Report: ISSUES

Function: Test, Adjust, & Balance

Forge HQ (Kansas City, MO)

Project: Forge HQ (Kansas City, MO)

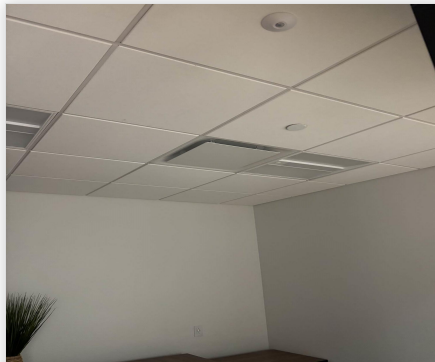
Issue Name : FCU-2: Broken Damper Handle
Description : The damper handle is broken. Proper Airflow could not be set.
Created By : National TAB **Assigned To :** National TAB - Kalen Kemp
Status : Open
Priority : Urgent **Asset Tag :** F2-2
Originated Date : 09/24/2025 - Kalen Kemp - National TAB

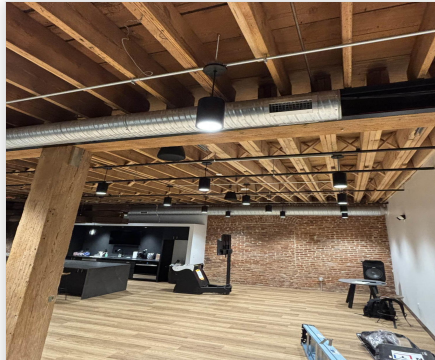
Issue Name : FCU-2: Missing Damper
Description : The damper for the office diffuser is missing. Could not set airflow to proper amount.
Created By : National TAB **Assigned To :** National TAB - Kalen Kemp
Status : Open
Priority : Urgent **Asset Tag :** F2-9
Originated Date : 09/24/2025 - Kalen Kemp - National TAB
